# Version Explanation for 100443/CON-7013 BMSC

## 100443 – Obsolete

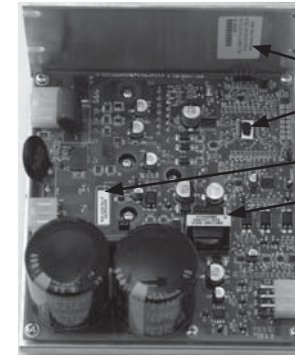
- First generation motor controller
- Known Issues: None
- If BMSC Fails:
  1. Replace with CON-7013.C
  2. Upgrade Software:
    - HhB - HHB-8144-X Rev. E or greater
    - HhB2 - HHB-8243-X Rev. C or greater
    - All other ovens: no software upgrade required

## CON-7013 Rev. A – Obsolete

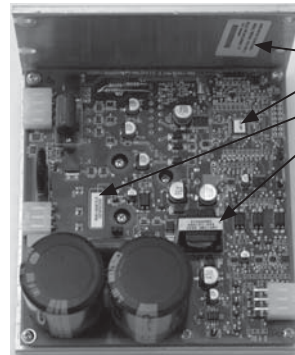
- Second generation motor controller
- Known Issues:
  - “F1” faults occur at startup and while cooking at 100%
- If BMSC Fails:
  1. Replace with CON-7013.C
  2. Upgrade Software:
    - HhB - HHB-8144-X Rev. E or greater
    - HhB2 - HHB-8243-X Rev. C or greater
    - All other ovens: no software upgrade required

## CON-7013 Rev. C – Active

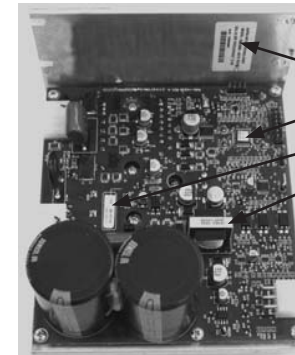
- Second generation motor controller
- Known Issues: None

How to Identify  
Supplier Revision: C  
Software Version: 1.50  
PCB Revision: J  
Transformer: Type B (vendor 1: “XFMR”) (vendor 2: “OBP/SMC”)

## CON-7013 Rev. B v1– Obsolete

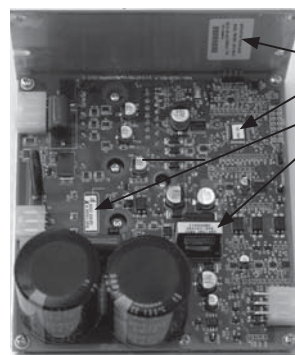
- Second generation motor controller
- Known Issues:
  - Better performance, but same issues as CON-7013 Rev. A
- If BMSC Fails:
  1. Replace with CON-7013.C
  2. Upgrade Software:
    - HhB - HHB-8144-X Rev. E or greater
    - HhB2 - HHB-8243-X Rev. C or greater
    - All other ovens: no software upgrade required
